JOYFUL VIEW SUBDIVISION
OGC RE2, LLC.
EL PASO COUNTY, CO

JOYFUL VIEW SUBDIVISION CONSTRUCTION DOCUMENTS

PCD FILING NO. SF2231

SAND FILTER BASIN PROFILE
TYPICAL SECTION
SCALE: NTS

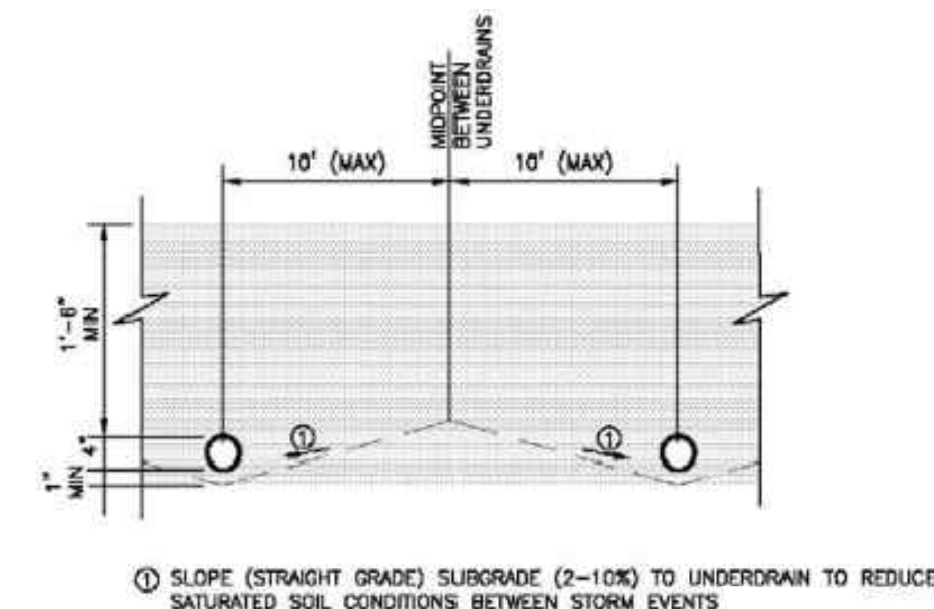
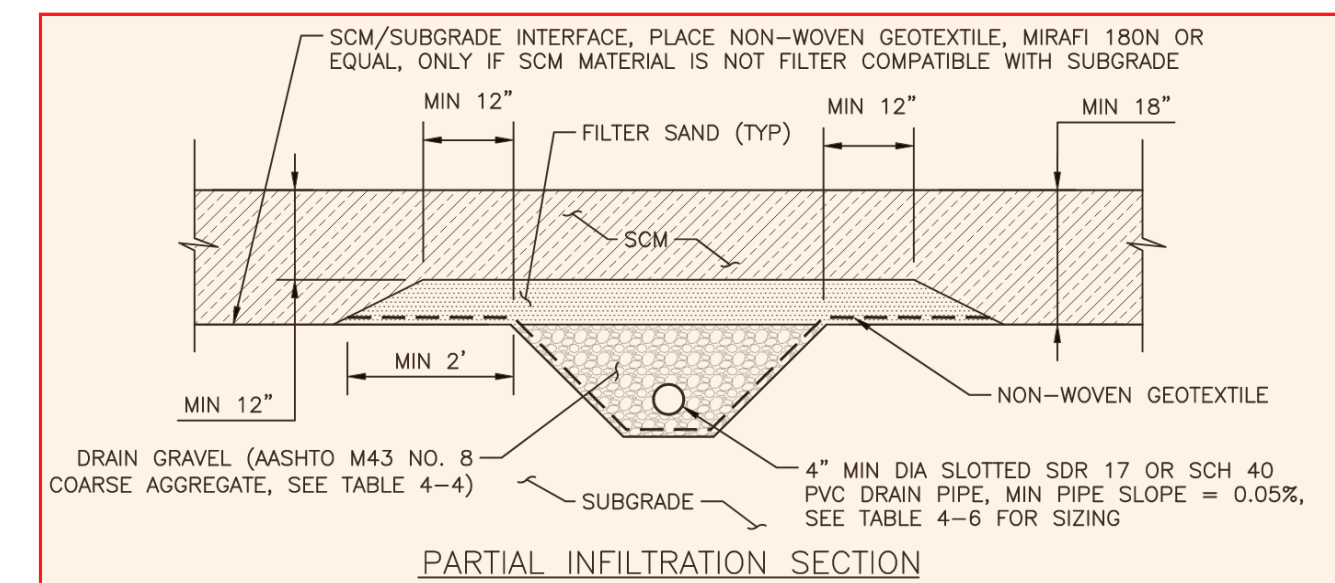
Revise all mention of CDOT filter material to MHFD's latest recommended material: ASTM C-33 sand.

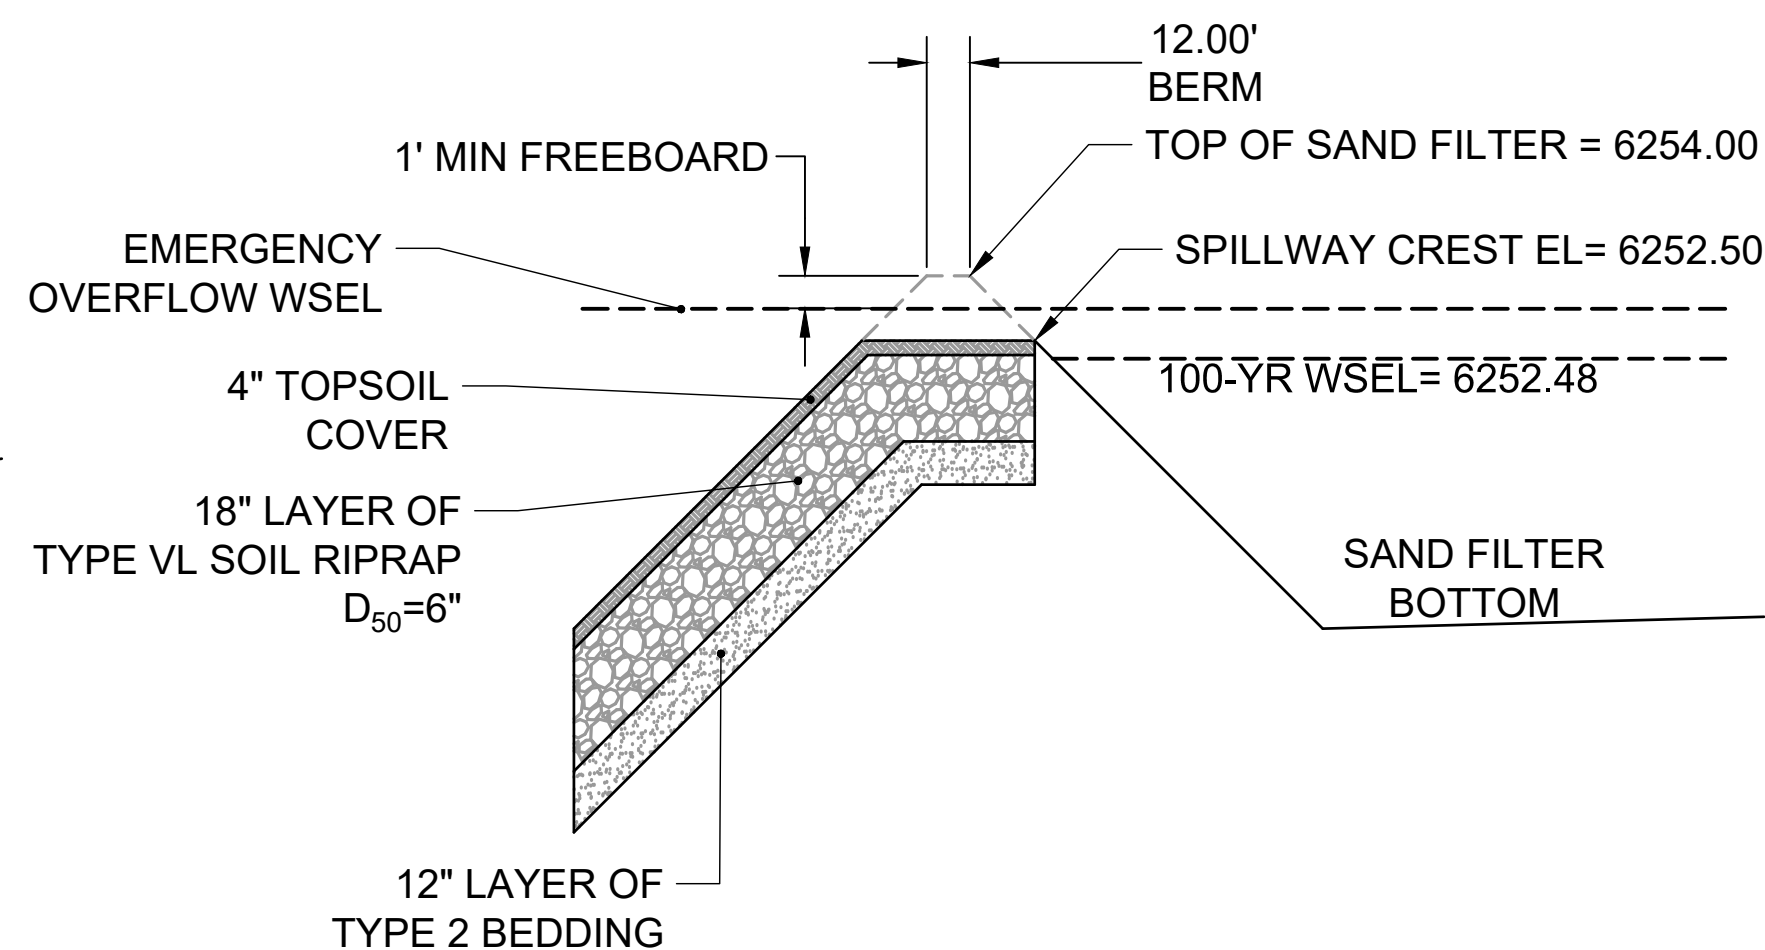
Show MHFD's latest detail for infiltration basins (shown below). Keep the other two screenshots you have in here, because I think they compliment this new detail.

SHEET
DT
10

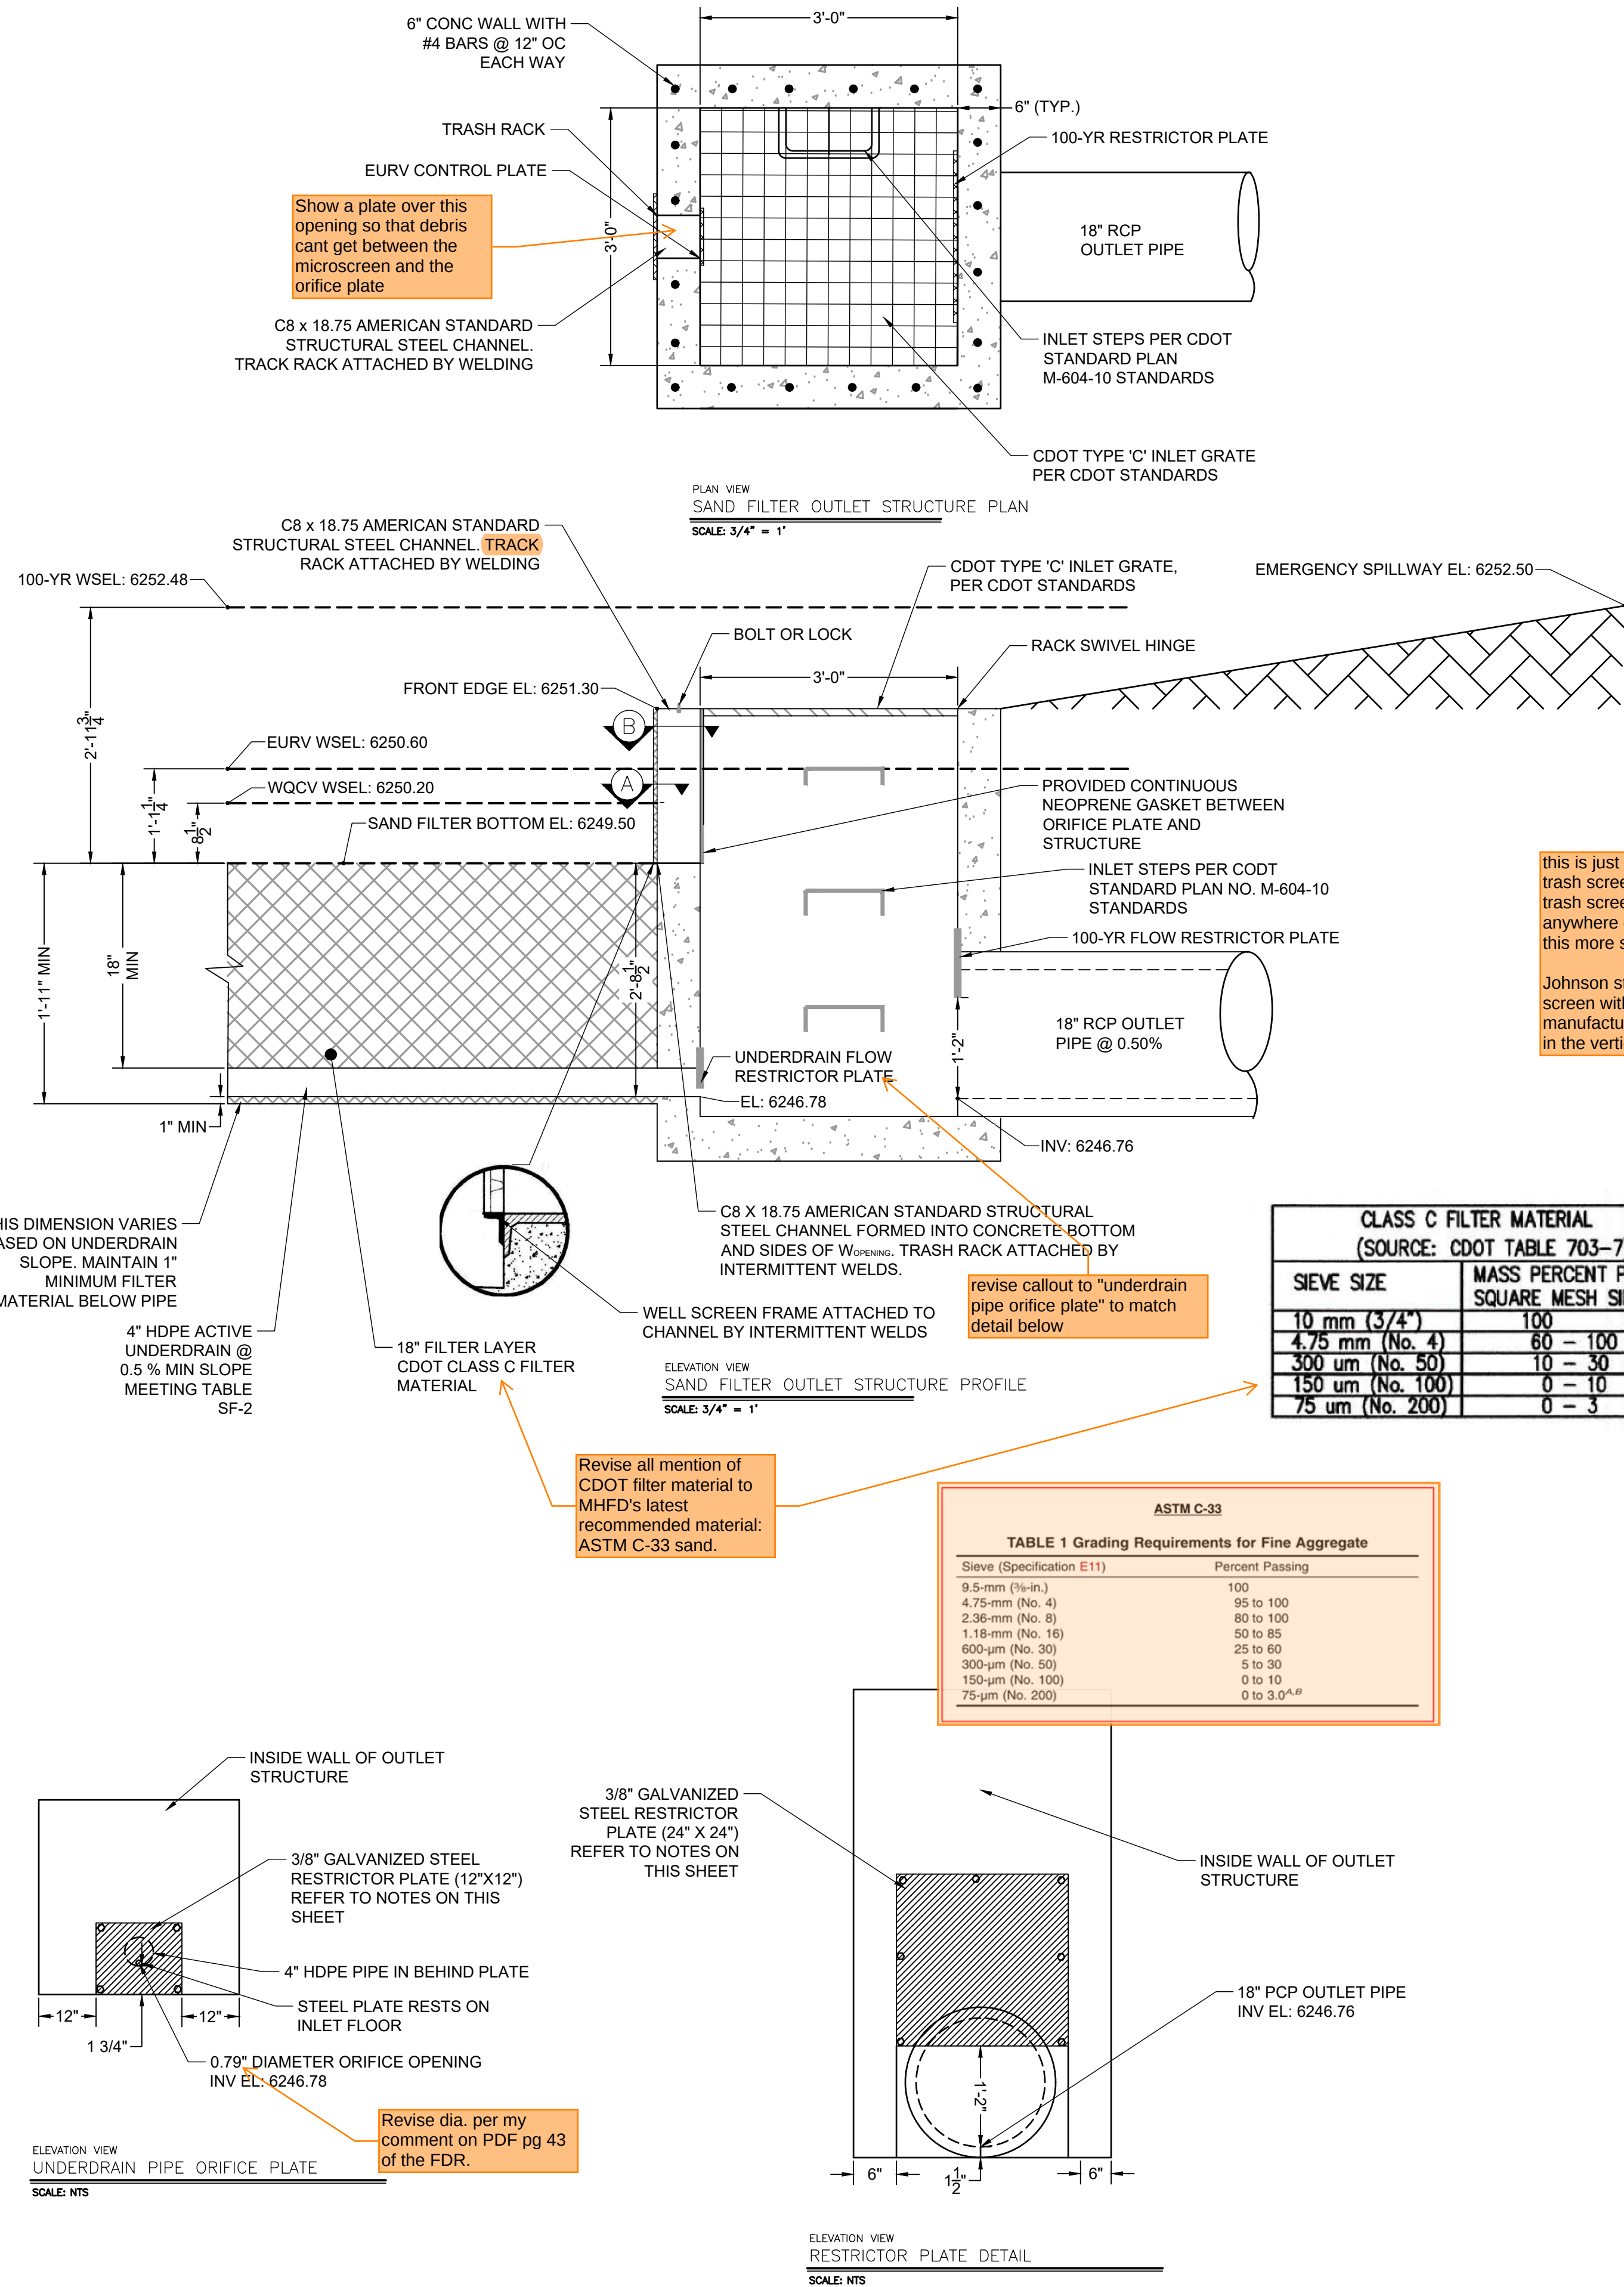
this is just a type of steel, not a trash screen type, I don't see the trash screen type called out anywhere on this sheet. Spec this more specific item:

Johnson stainless steel well screen with #93 VEE wire, manufactured with exterior bars in the vertical orientation.

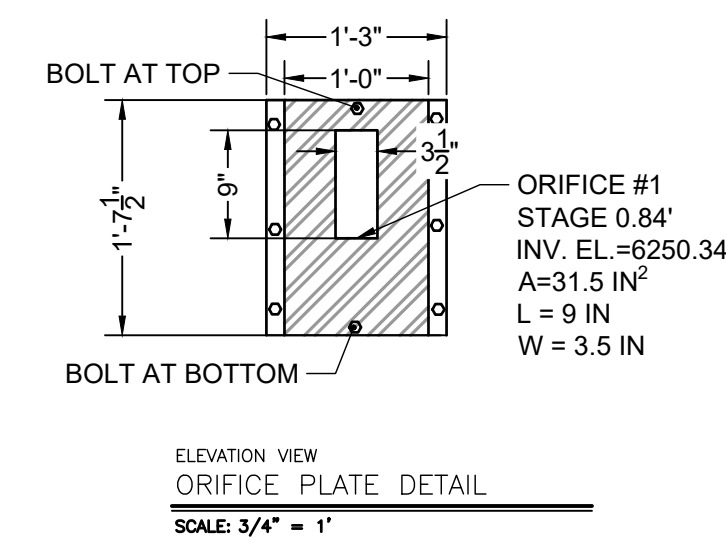
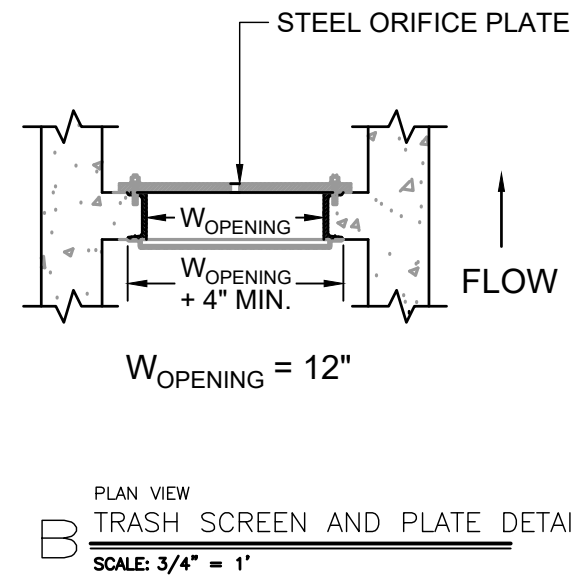
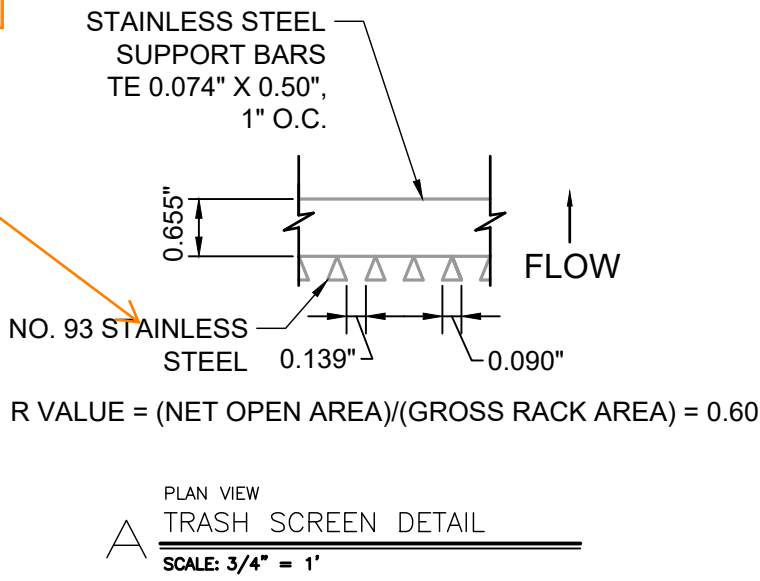
Provide more detailed gasket info like thickness, width, brand/model, etc.

Based on input gathered from industry experts, below is the recommended gasket spec:

The gasket shall be made of 1/4-inch thick, 60 durometer EPDM rubber in a continuous sheet the size of the orifice plate. The sheet shall be placed between the orifice plate and the concrete wall, with the width of the overlap between the plate and the concrete. Openings shall be cut into the sheet corresponding to the plate bolt holes and the concrete wall opening, cuts made either by the contractor in the field or by the manufacturer. Or equivalent gasket approved by EPC. Note that caulk is not an approved equivalent and will not be accepted by EPC.
